LANL Permit
TA-16 08

From: Smith, Michael [MSmith@TechLawInc.com]
Sent: Thursday, July 02, 2009 6:10 AM
To: Smith, Michael; Kay, Rebecca, NMENV
Cc: Bearzi, James, NMENV; Pullen, Steve, NMENV; Kieling, John, NMENV; Lindsay Lovejoy; lindsayl@cybermesa.com; Cobrain, Dave, NMENV
Subject: RE: TA-16 furan results

Attached is the second figure illustrating the extent of air modeling results problematic for furans when 250 lbs of HE contaminated waste is burned at TA-16-388. General comments on the figure appear below.

Attachments: Extent for 250 lb burns.jpg

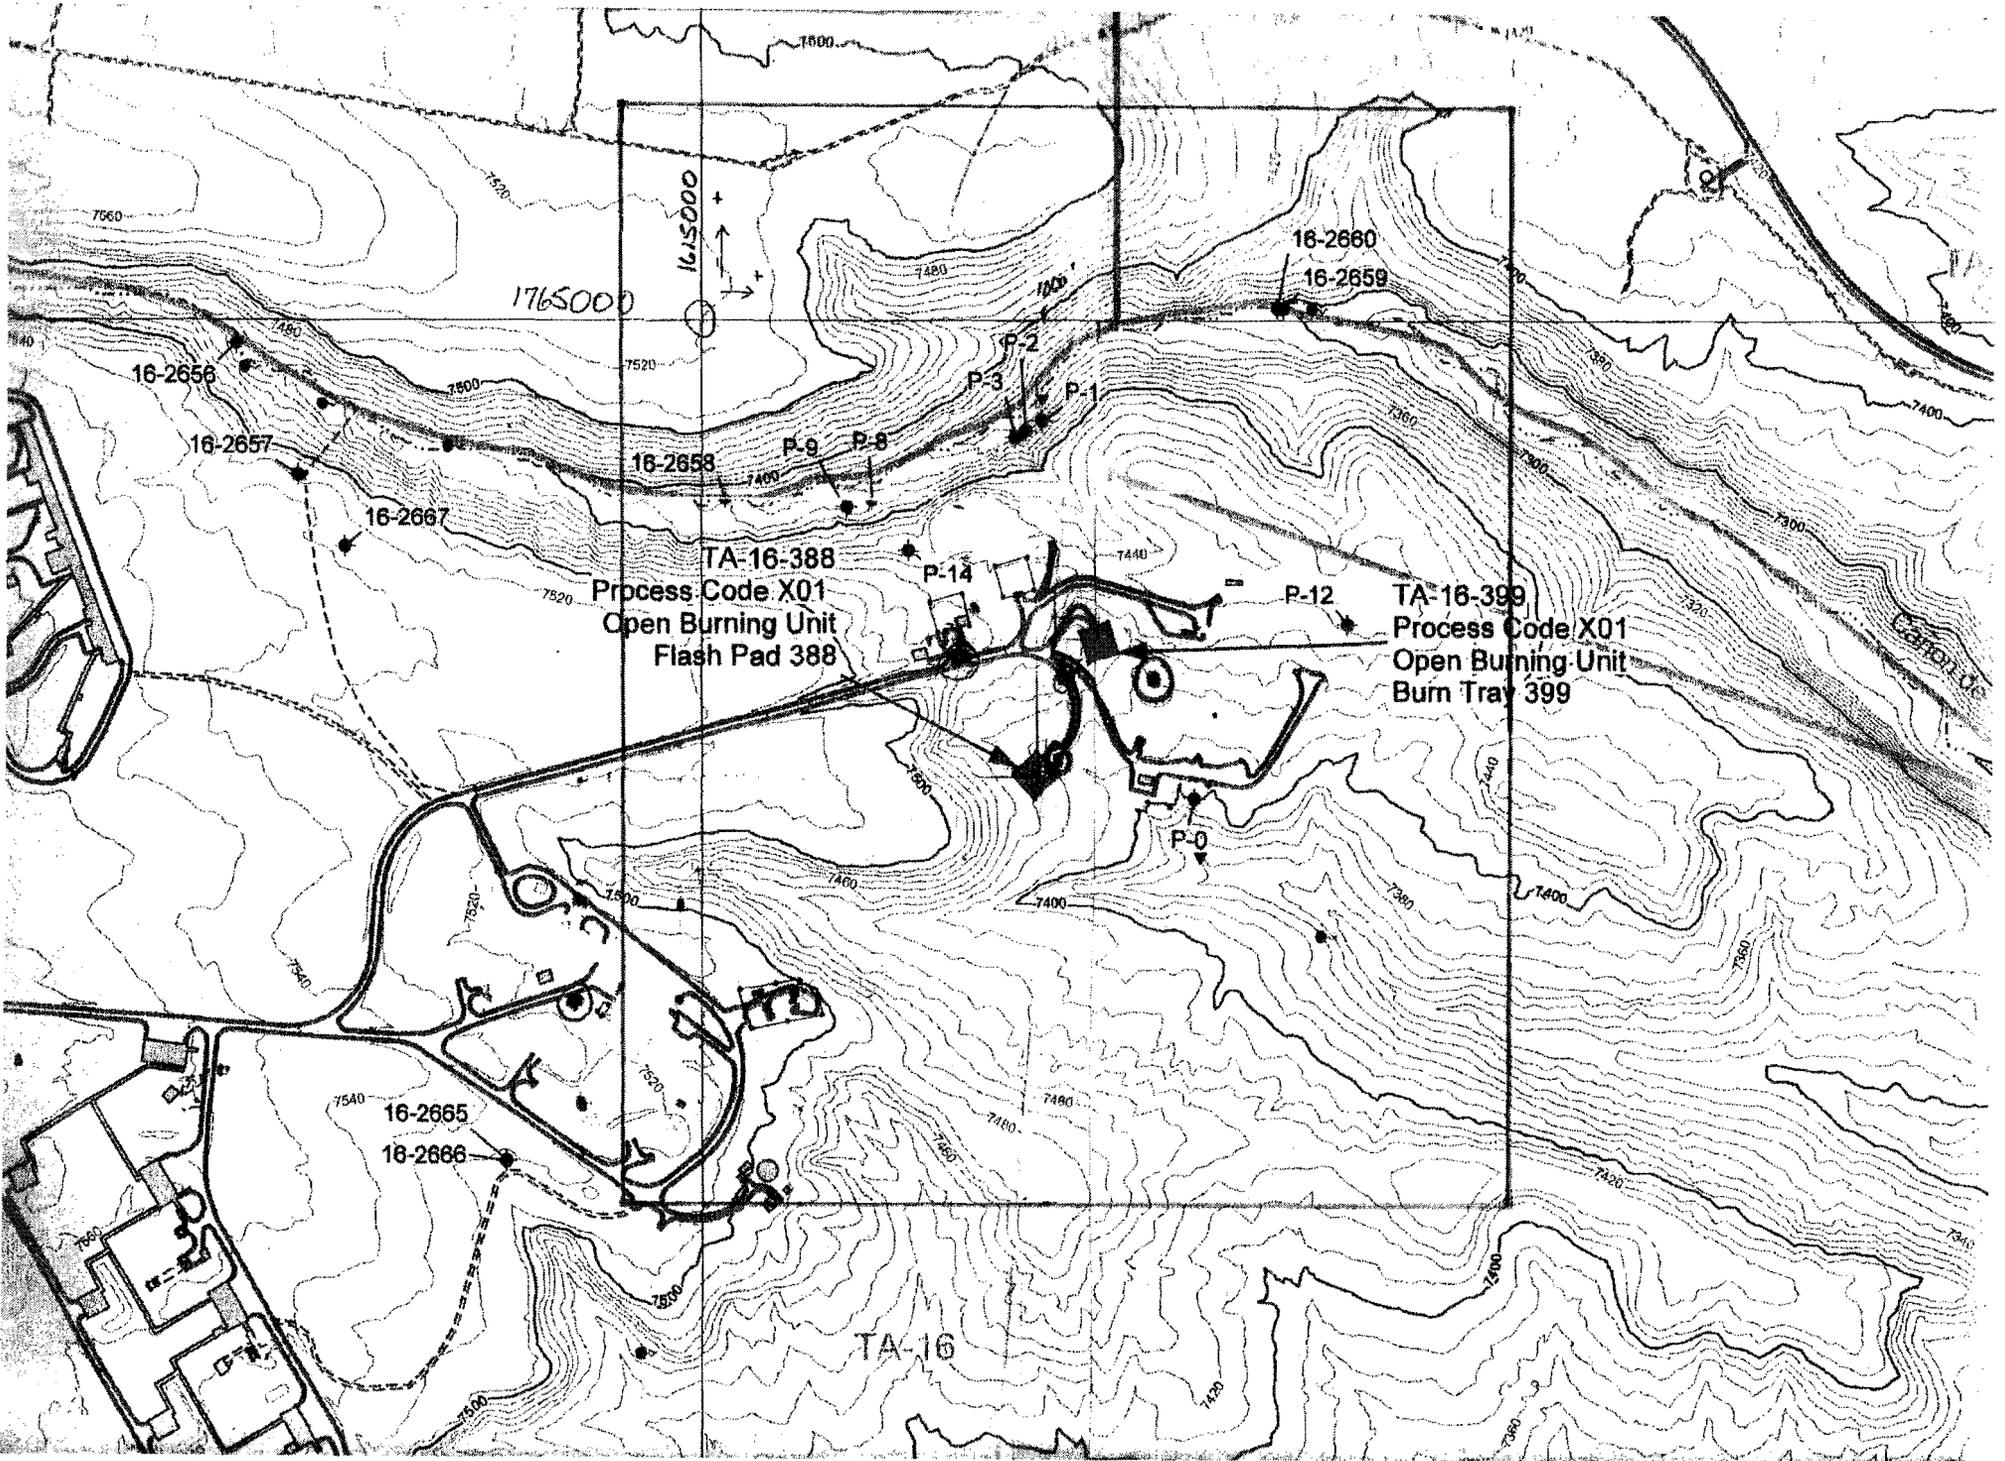
Note the dots circled in red locate the overall maximum impact points for burns at TA-16-388 (dot closest to the flash pad at 388) and TA-16-399 (dot just southeast of the burn tray at 399). It appears that the dot representing the maximum impact location for TA-16-399 corresponds to LANL's sampling point 6. The maximum impact location for TA-16-388 does not appear to correspond to a sampling point.

Note the extent for 250 lbs corresponds to the full modeling grid. For 35 lb burns, the eastern boundary is still defined by the eastern edge of the modeling grid but the extent is reduced to the north, south, and west.

The scale on these hand-drawn masterpieces is 1 inch = 500 feet. Thus, the eastern edge of the modeling grid is approximately 1250 feet from TA-16-388.

I would not locate a background sample within the red squares. I believe LANL's background sample (sampling point 3) is located in the southwest corner of the box defining the extent for 35 lb burn events.
